DOCUMENT: Unit 2 Offsite Dose Calculation Manual

TITLE: Revision 8 to the Offsite Dose Calculation Manual

EXECUTIVE SUMMARY: Revision 8 to the Unit 2 ODCM was completed to comply with a milk location change in the environmental program. In addition, a typographical error was corrected in Part I, liquid dose factors were corrected in Part II for typographical and/or data input errors identified from an independent verification, and a source document for an environmental parameter was corrected.

FIGURE 5.1-2

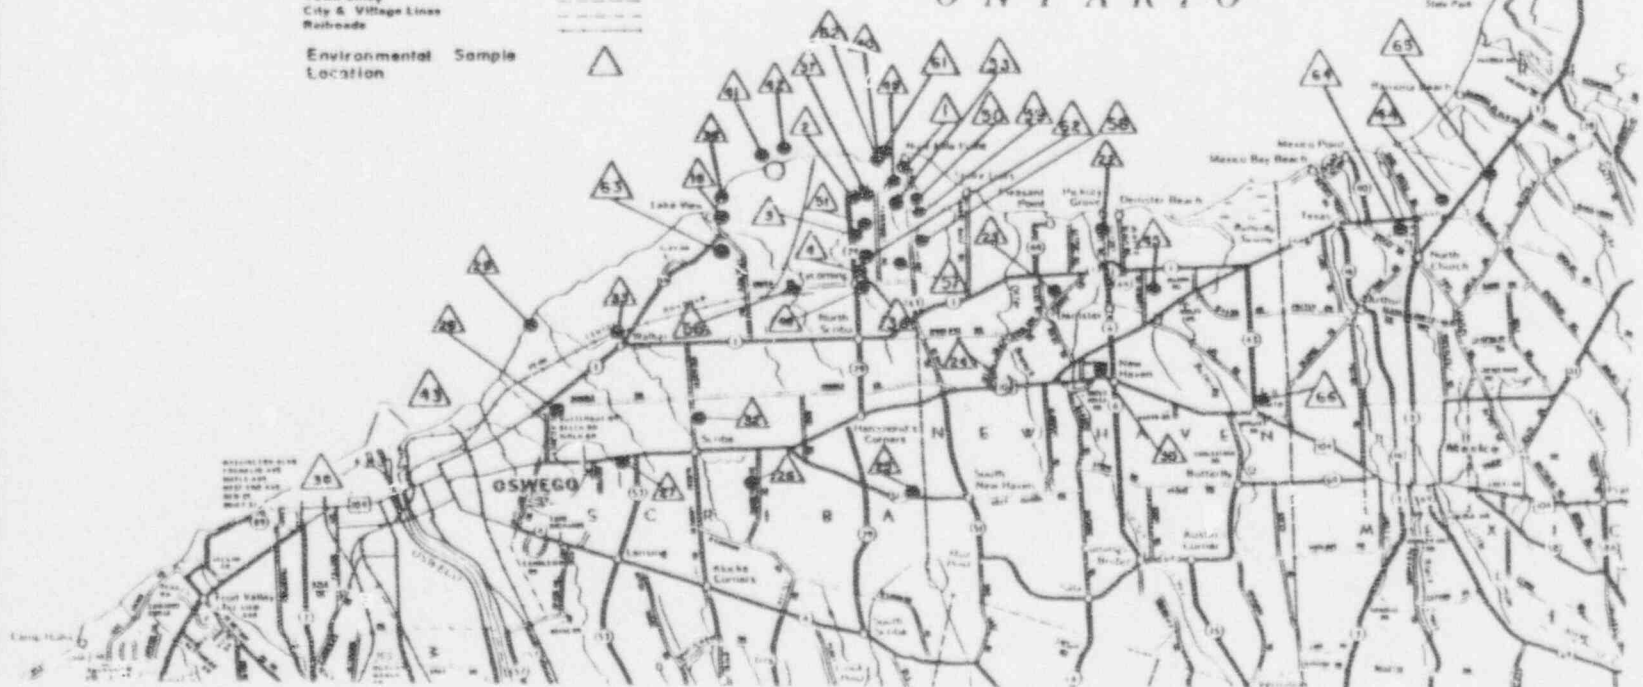
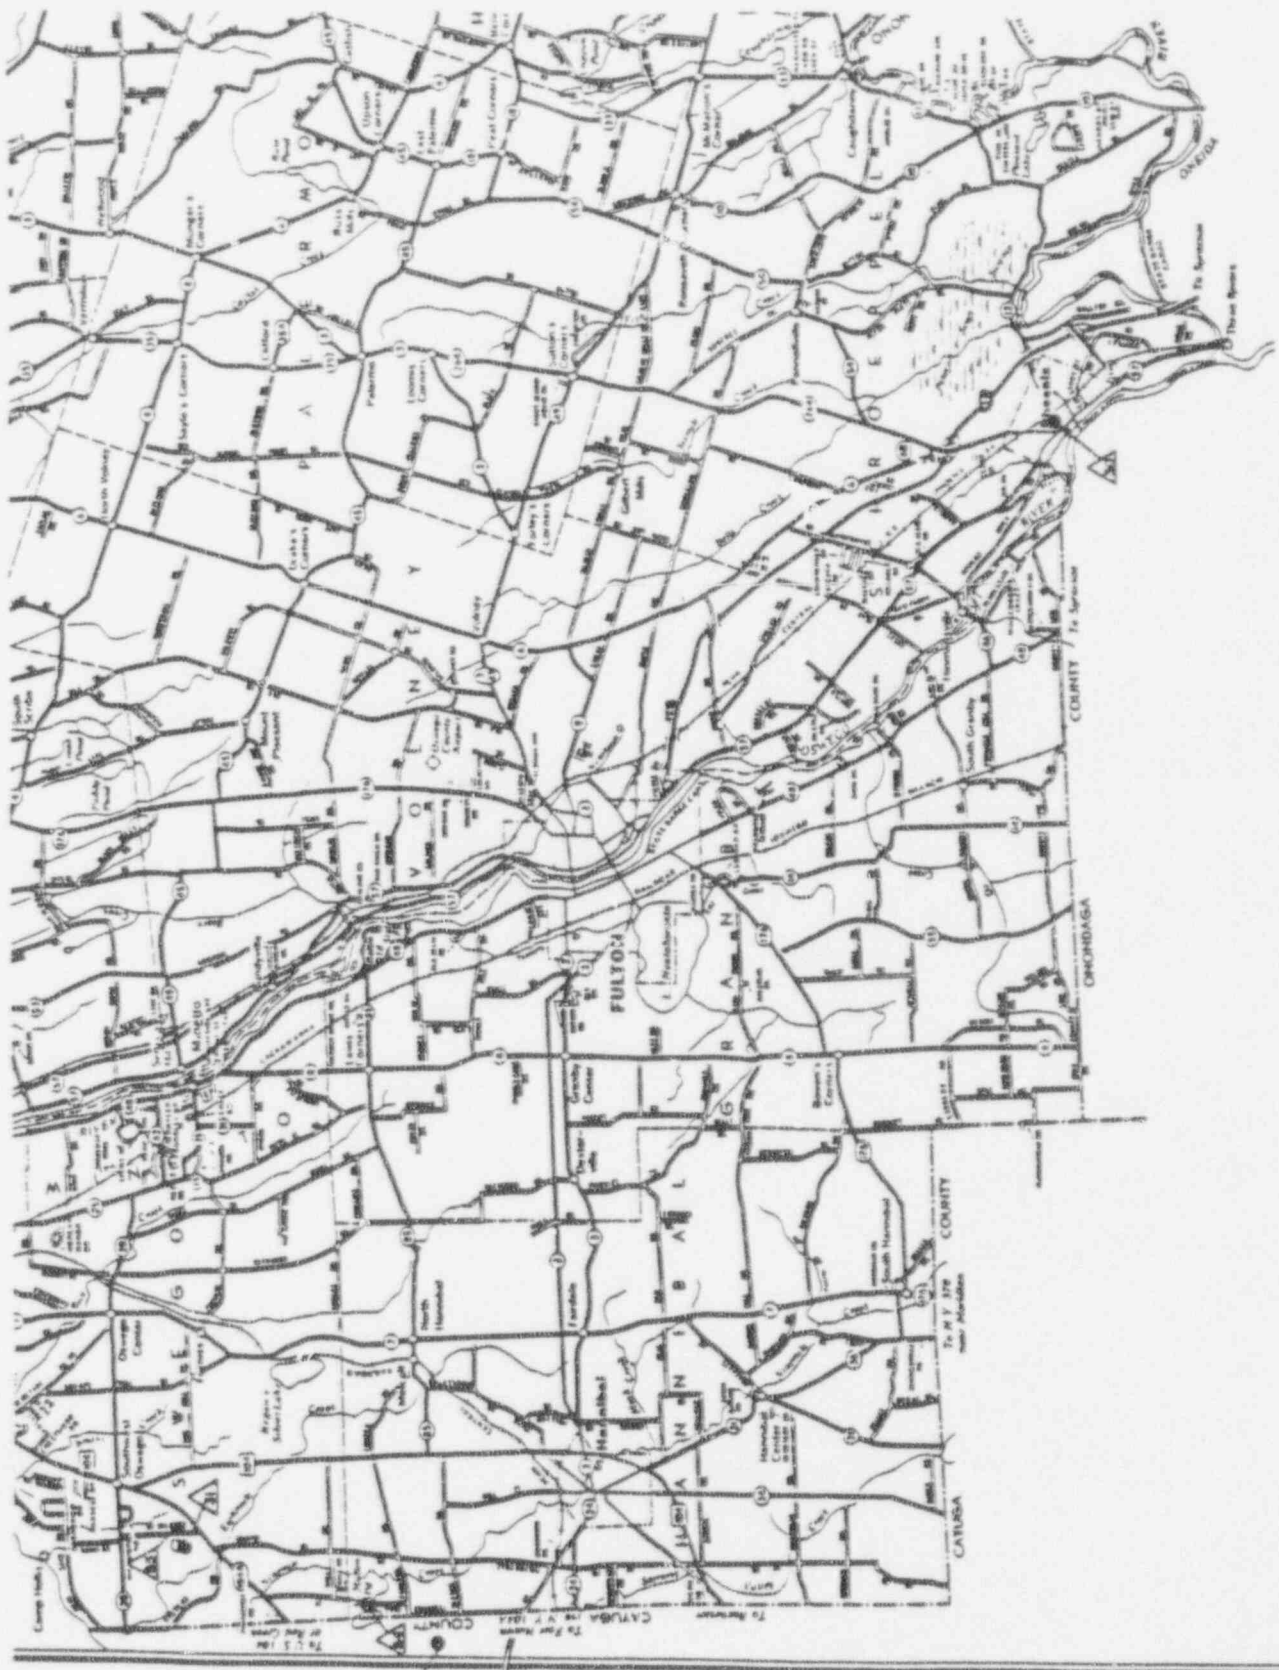
- (2) Part II - pp. 28, 29, & 31 - Tables 2-2, 2-3, & 2-5 - The Np-239, Sr-92, I-133, Ba-140, Tc-99m and W-187 values contained various typographical and/or data input errors as identified from an independent verification. As these nuclides were not identified and quantified during the period from the last ODCM revision, there is no impact on the compliance calculations for liquid effluents.
- (3) Part II - p. 55 - A correction to the source document for the shoreline usage factor on Table 3-24 was completed.
- (4) Part II - pp. 58, 104a,c - The milk location number 46 was deleted. The farmer sold his herd of cows. In addition, pp. 104a and 104c were deleted as no sample locations were on those map sections of Figure 5.1-2. The pages were re-numbered.
